REMARKS

AMENDMENTS TO THE DRAWINGS

2/5

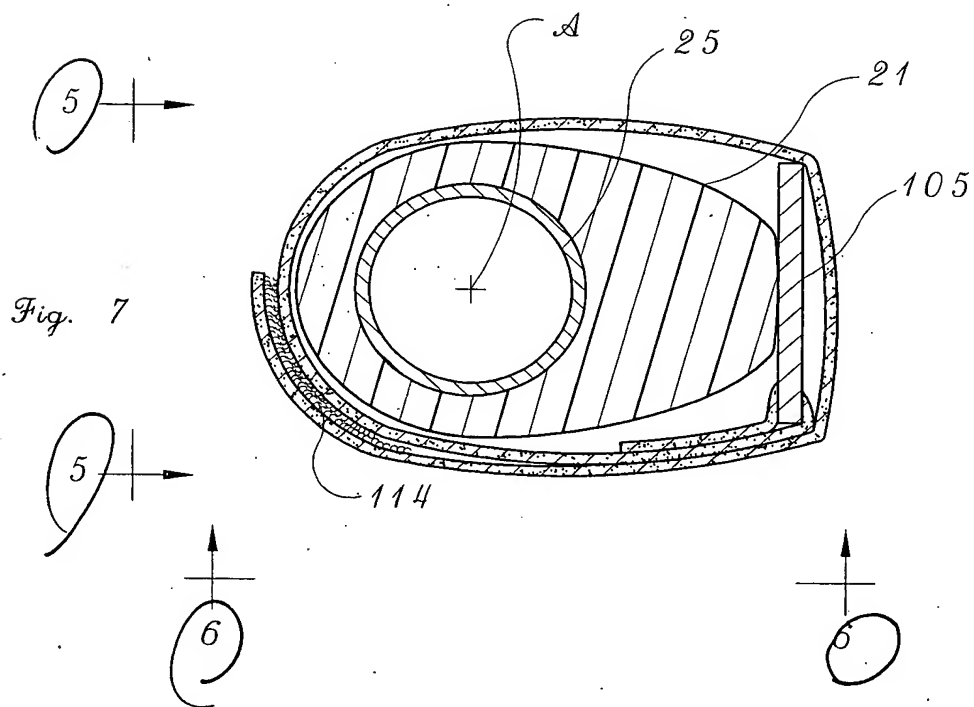
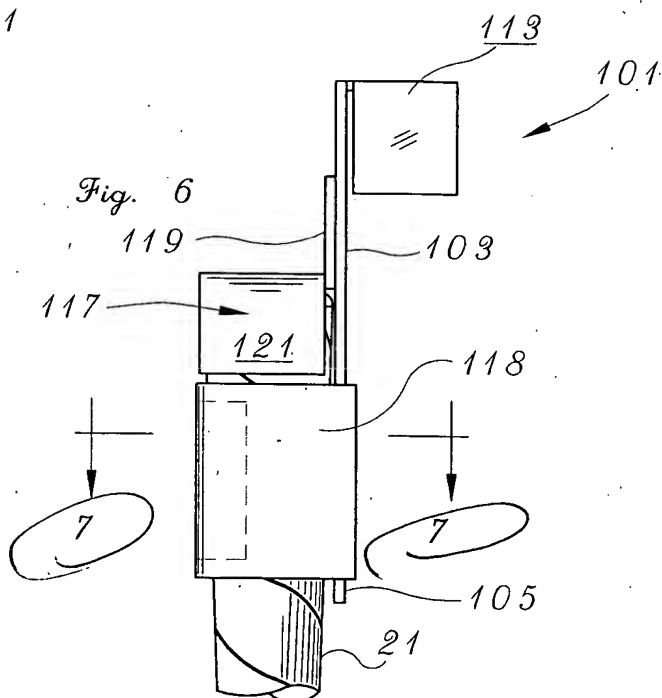
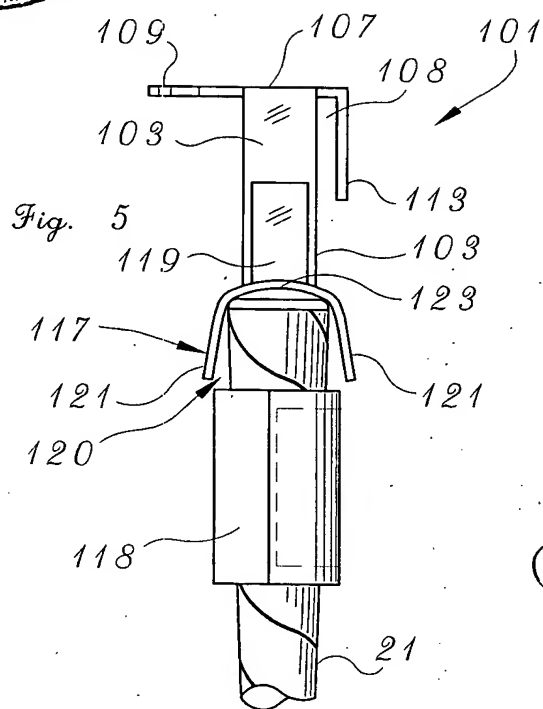
Figure 6 has been amended to correct a section reference to Figure 7 from Figure 11 in two places. Likewise, Figure 7 has been amended to correct two section references, to Figure 5 from Figure 9 and to Figure 6 from Figure 10, both in two places. This amendment conforms the indicated figures to the Specification at 4 lines 17 - 22, where the respective cross sections are discussed.

The correction is needed to eliminate an artifact of figure re-numbering which occurred before the application was filed. Figures 5, 6 and 7 had been numbered 9, 10 and 11 respectively. The change found its way into the Specification at the page and lines indicated above, and in the Figure numbers themselves, but the section references in those figures was not changed. No new matter has been added.

1. In Figure 6, amend the drawing reference in the cross section indicator from 11 to 7, indicating that the section is shown in Figure 7, not Figure 11.
2. In Figure 7, amend the drawing reference in the section indicator to the left from 9 to 5, indicating that the view is shown in Figure 5, not Figure 9. Likewise, amend the drawing reference in the section indicator beneath Figure 7 from 10 to 6, indicating that the view is shown in Figure 6, not Figure 10.

Redline marked copies of Sheet 2/5, containing the above Figures 6 and 7, accompany this response. A replacement for Sheet 2/5 has been conveyed on even date herewith to the Official Draftsman, with indication that this amendment is being submitted herein to the examiner for review.
